November 29, 2000
GO2-00-197

Docket No. 50-397

Subject: **WNP-2, OPERATING LICENSE NPF-21
INSERVICE INSPECTION PROGRAM PLAN
RELIEF REQUESTS 2ISI-21 THROUGH 2ISI-24**

This letter submits four relief requests and one commitment change to our Second 10-Year Inservice Inspection Program Plan (Reference 1) for NRC review and approval.

Figure 2ISI-24-1

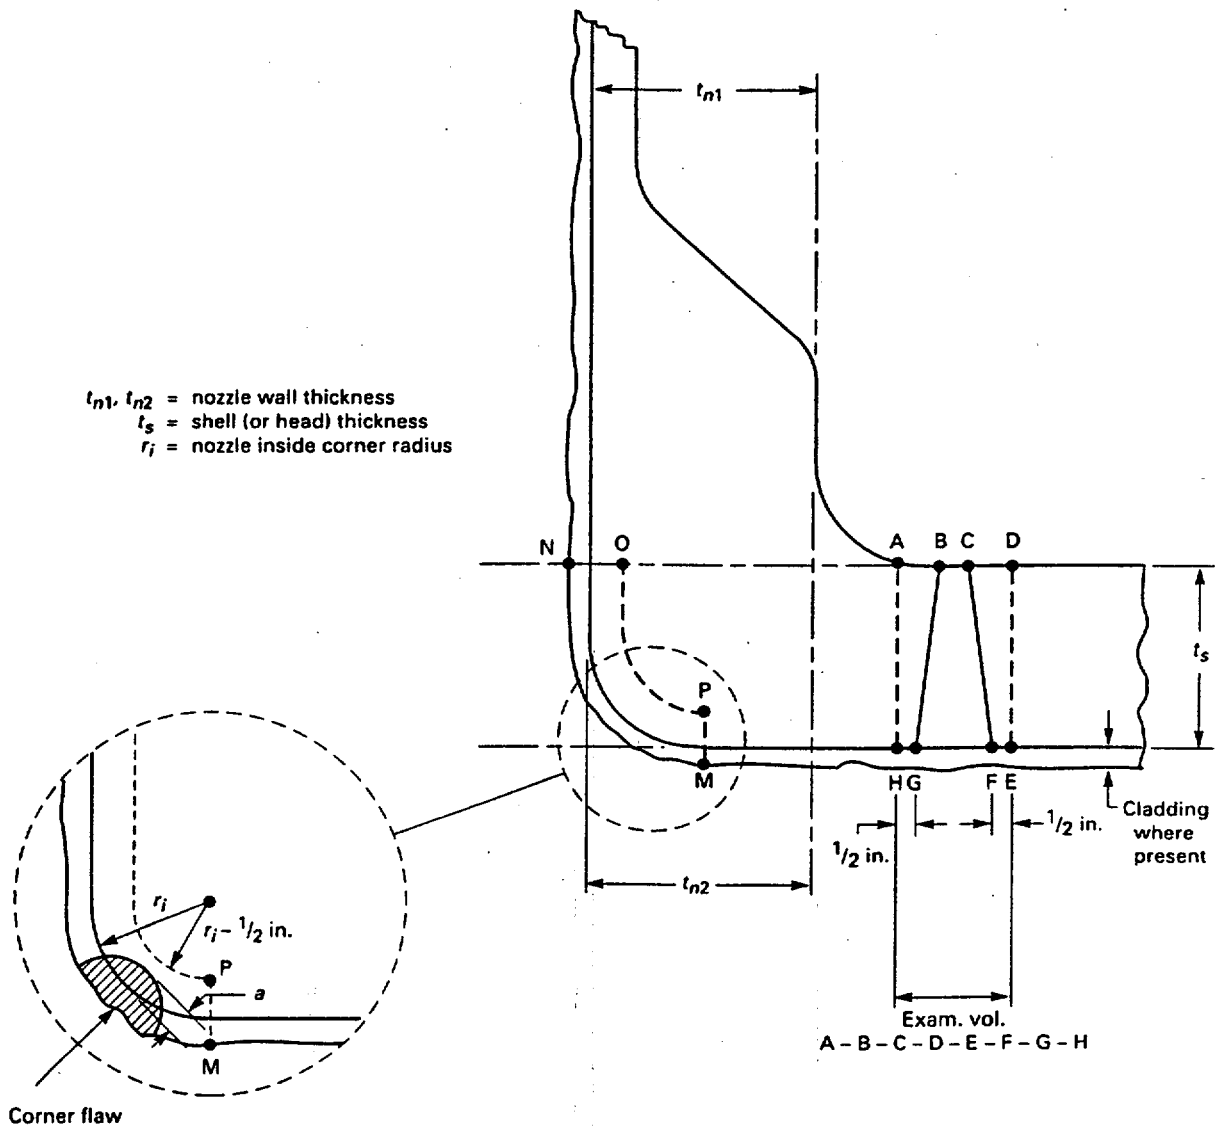
Perform examinations in accordance with Figure 2ISI-24-1 and ASME Code, Section XI, Division 1, 1995 Edition, 1996 Addenda, Appendix VIII, as required by 10CFR50.55a.

The current examination volume for the Reactor Vessel pressure retaining nozzle-to-vessel welds includes base metal far beyond the weld. The new examination volume reduces the base metal volume that will be examined. This removed base metal volume has been extensively examined during manufacture, preservice inspection, and inservice inspection. All these previous examinations have shown that this volume is free from flaws. It is unlikely that a new flaw will develop in this volume due to the low stresses in the base metal away from the weld.

The new examination volume, as shown in Figure 2ISI-24-1, defines a volume that includes the weld and heat affected zone. Inservice flaws are most likely to develop in this volume, since stresses caused by welding are concentrated at or near the weld.

C-D-E-F
 B-C-F-G
 A-B-G-H
 M-N-O-P
